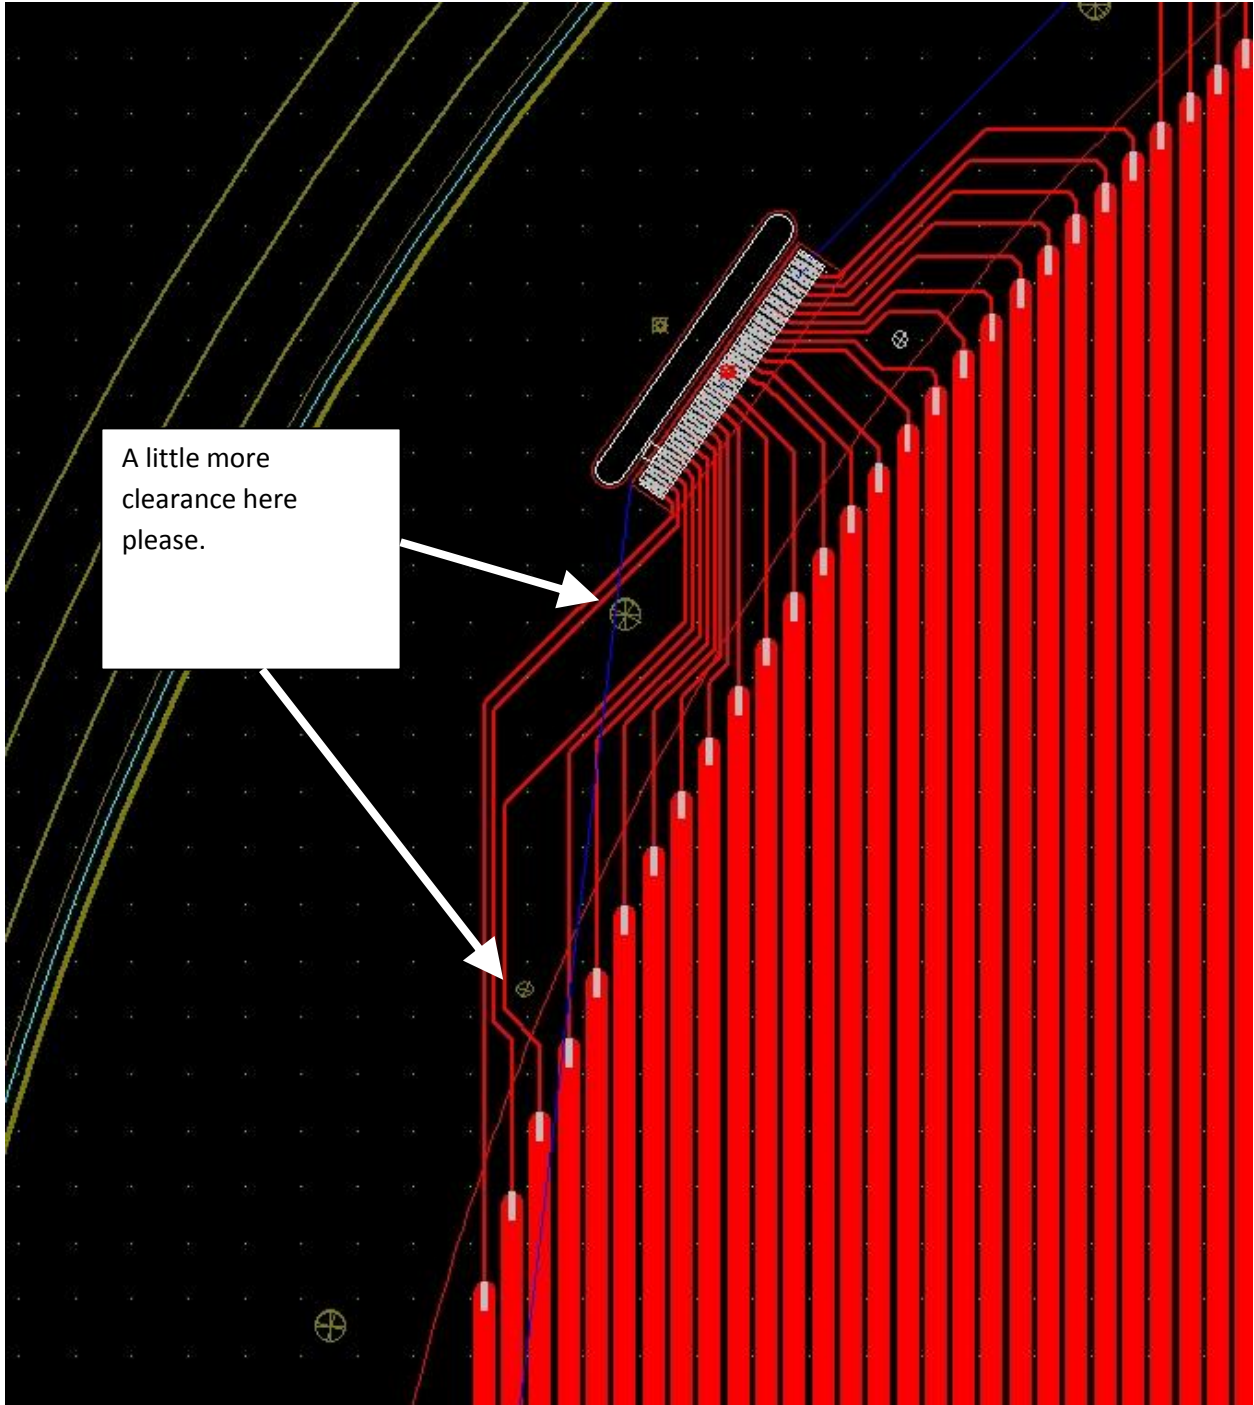
Delete vent holes at 7.5 and 22.5 degrees and replace with single hole at 13.6 degrees.

A little more clearance here please.

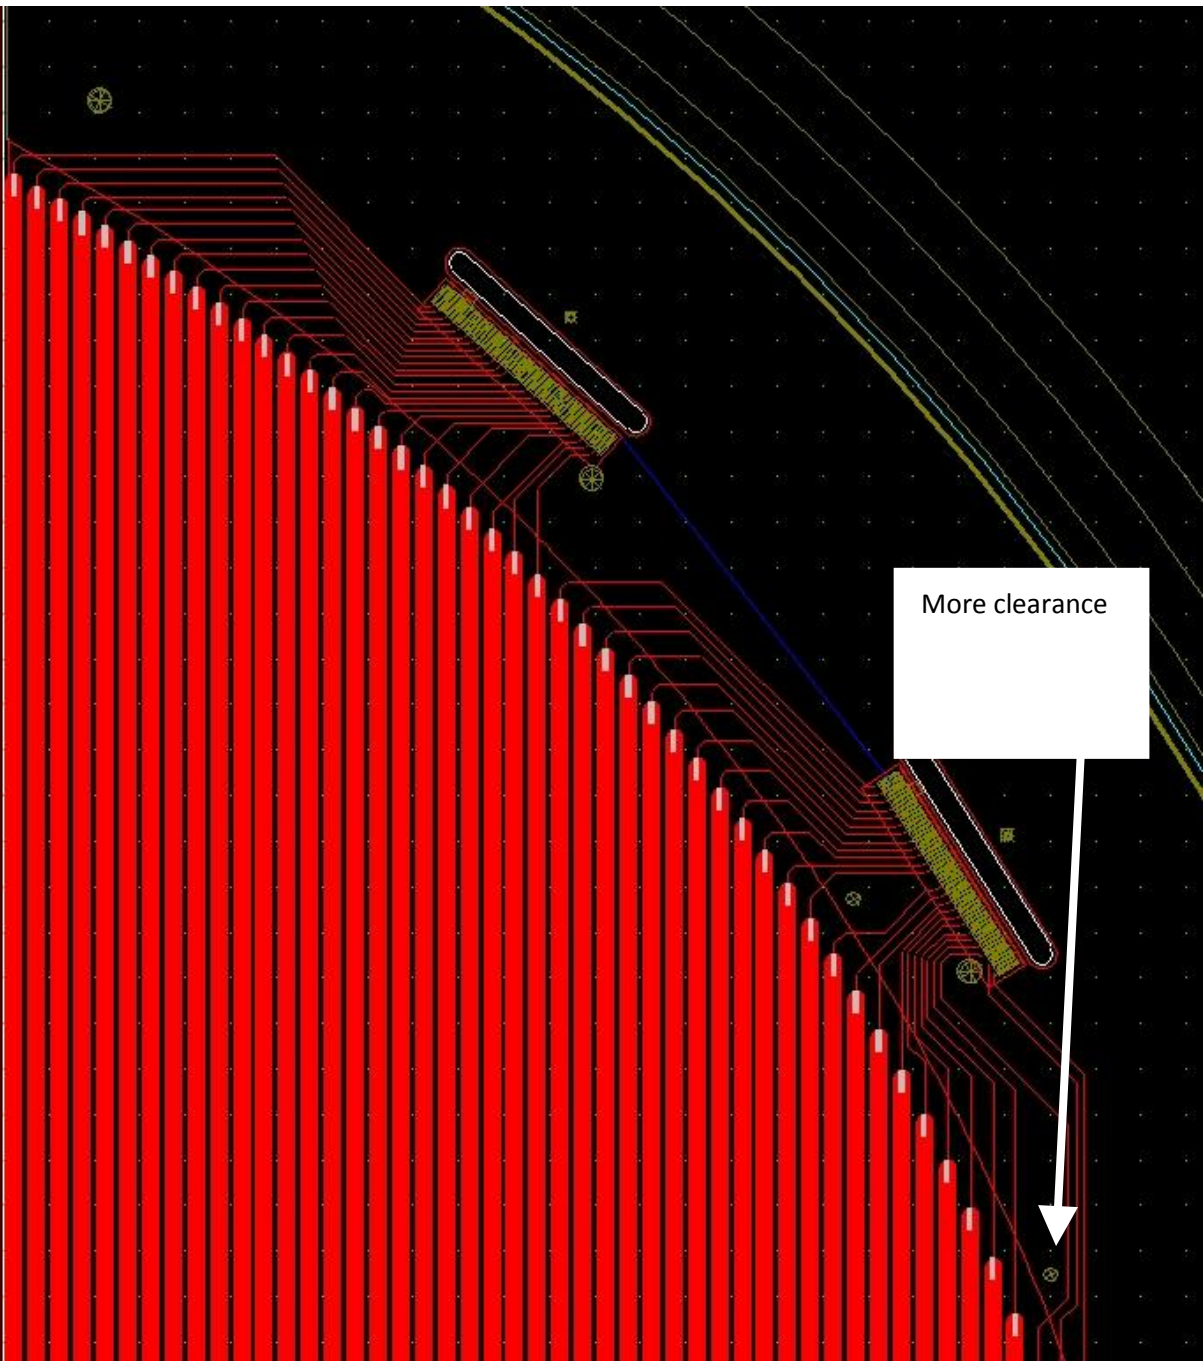
More clearance

DETAIL A

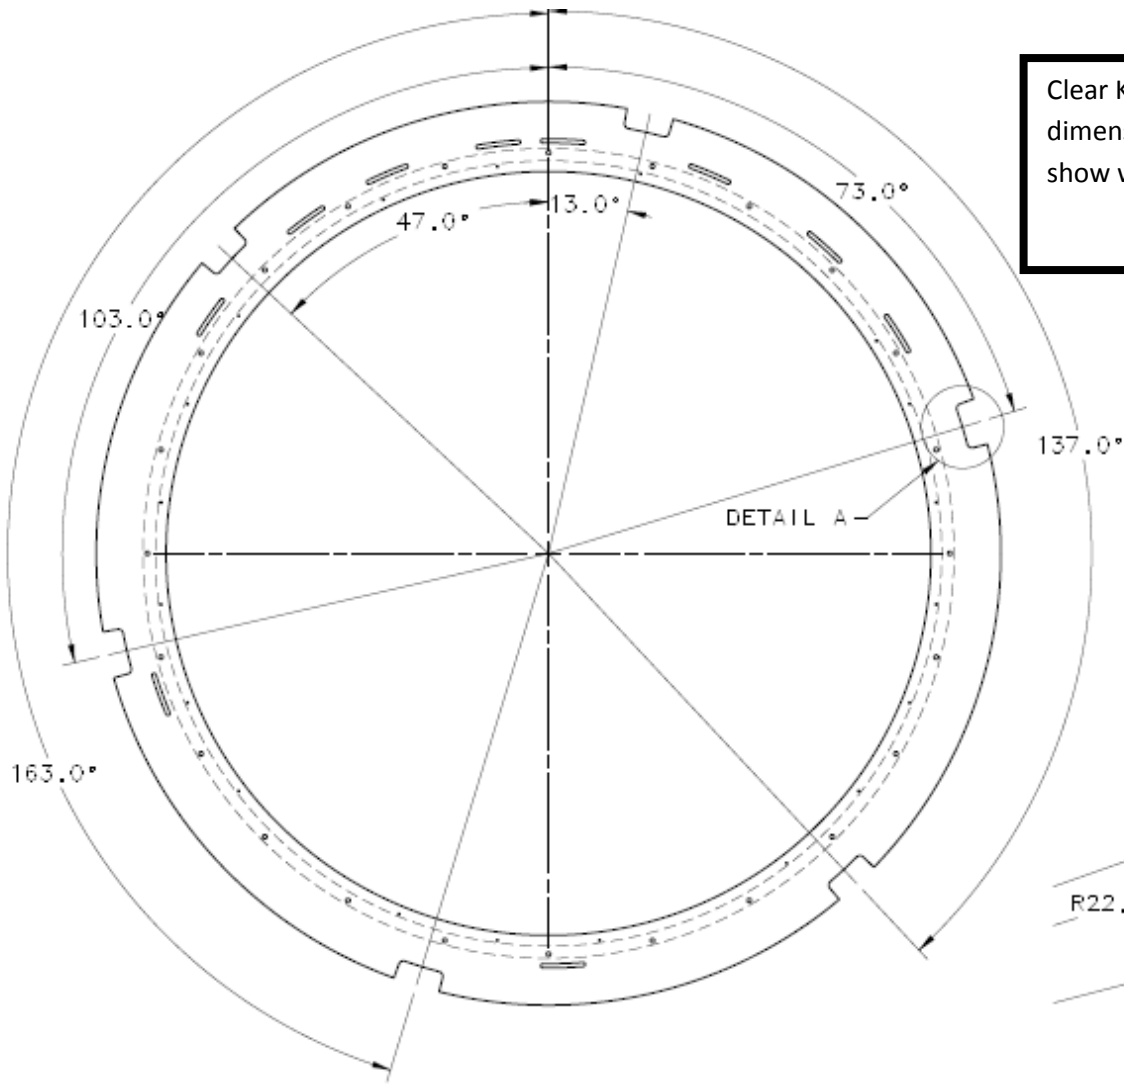
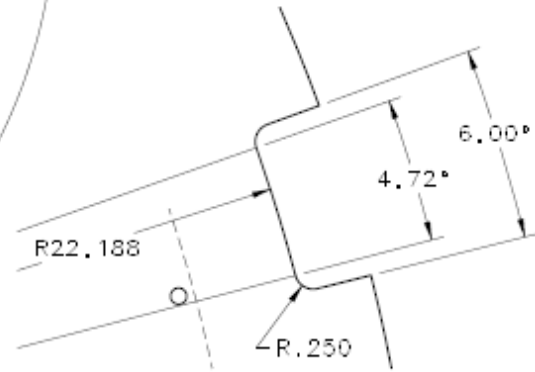
Clear Kapton from the 4.72 degree dimension to the 6 degree dimension to show where the flap cuts are.

Right panel

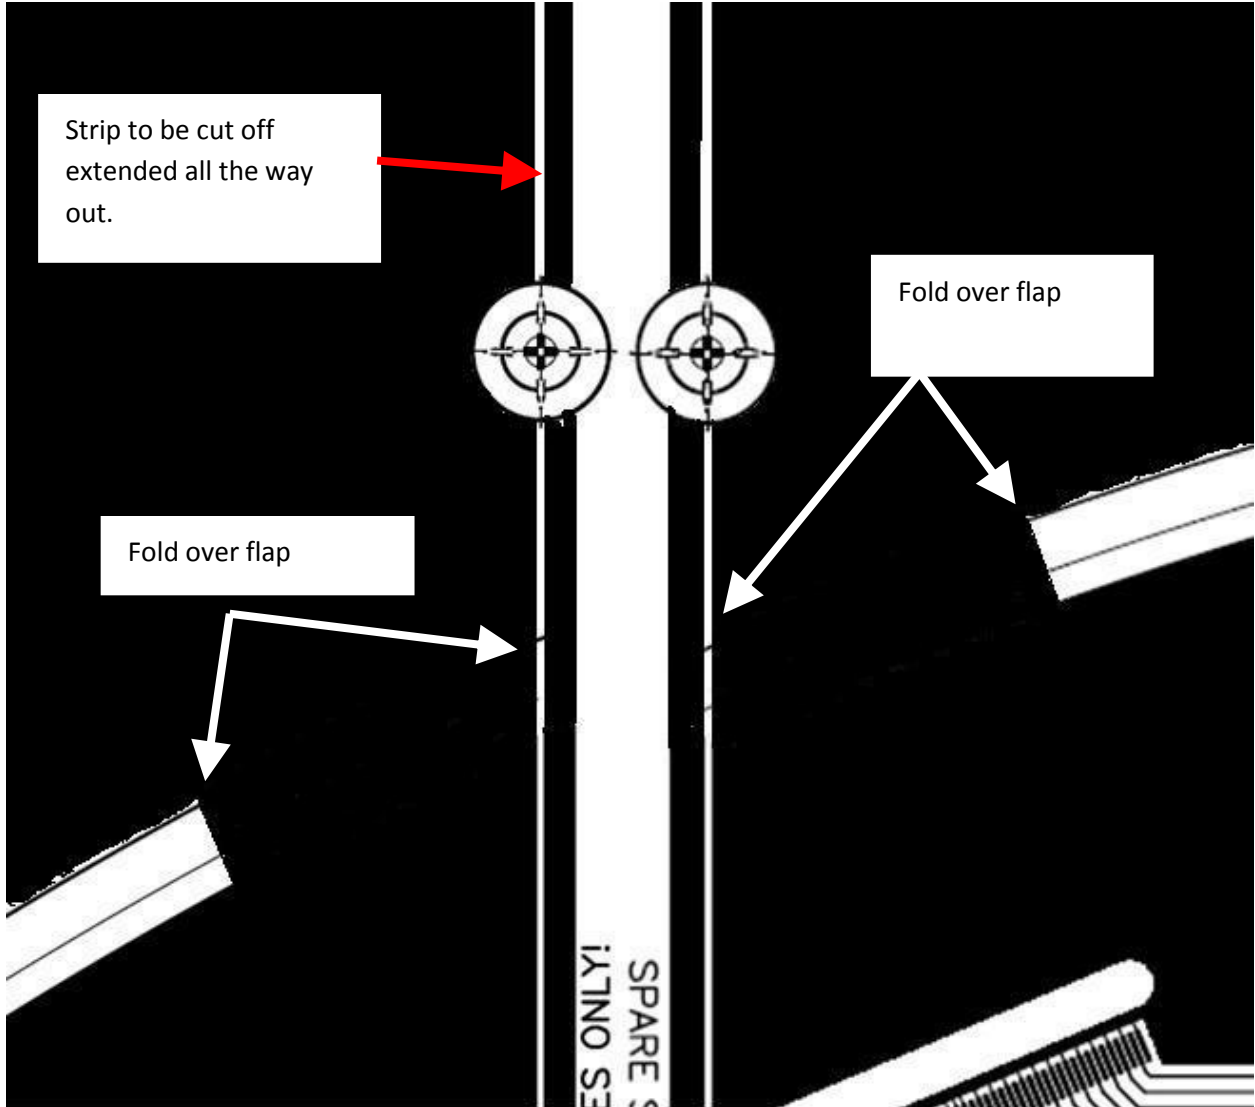
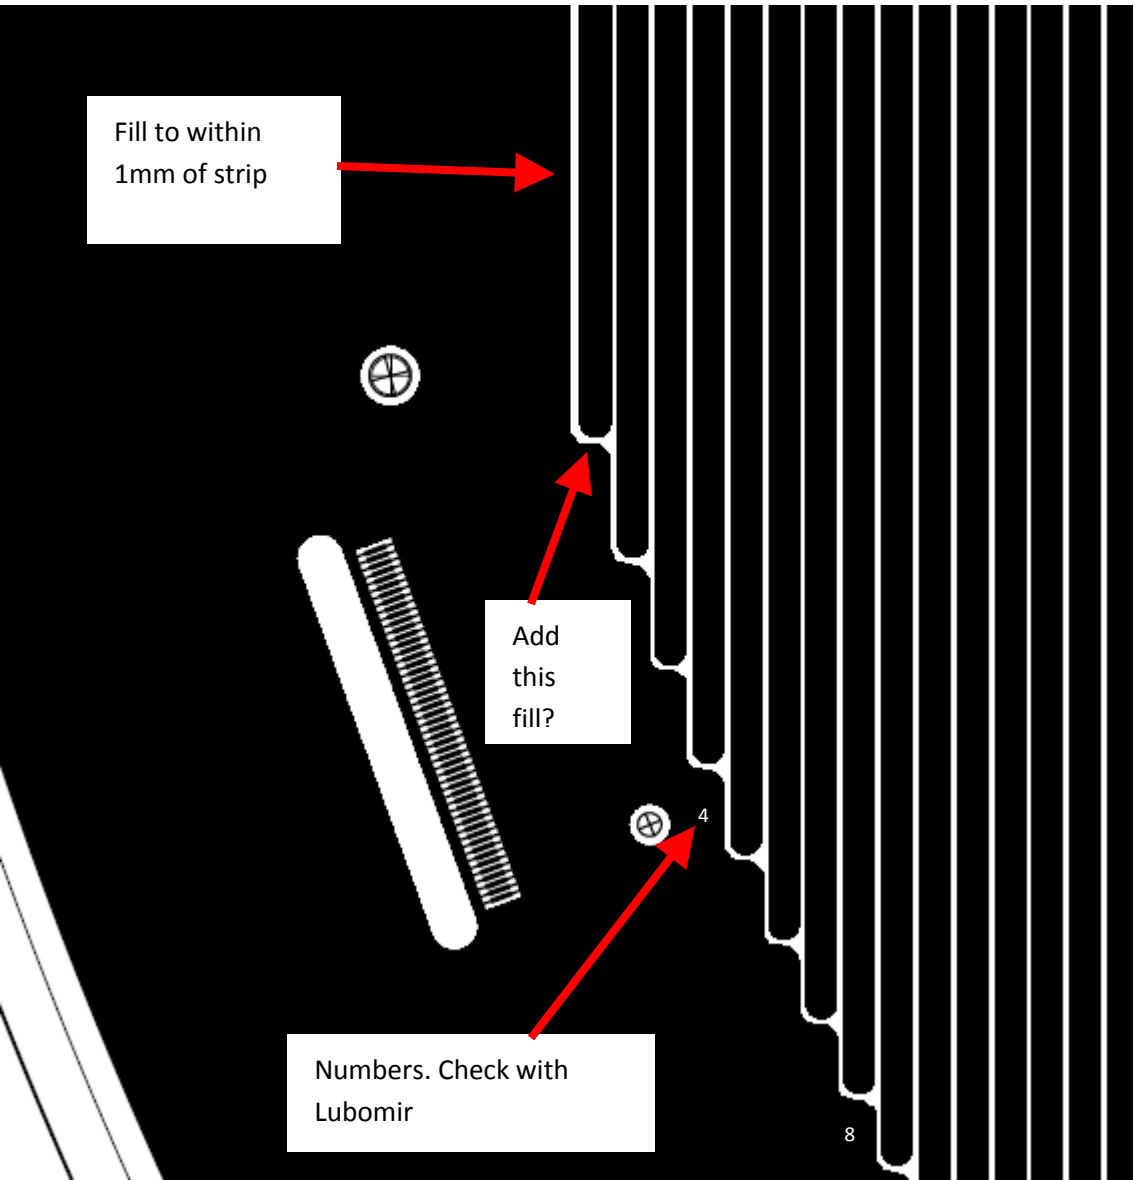
Shorten daughter card by a total of 3.5mm. The solder area moves radially outward by 1.5mm.

Try to improve clearance of traces around bolt holes.
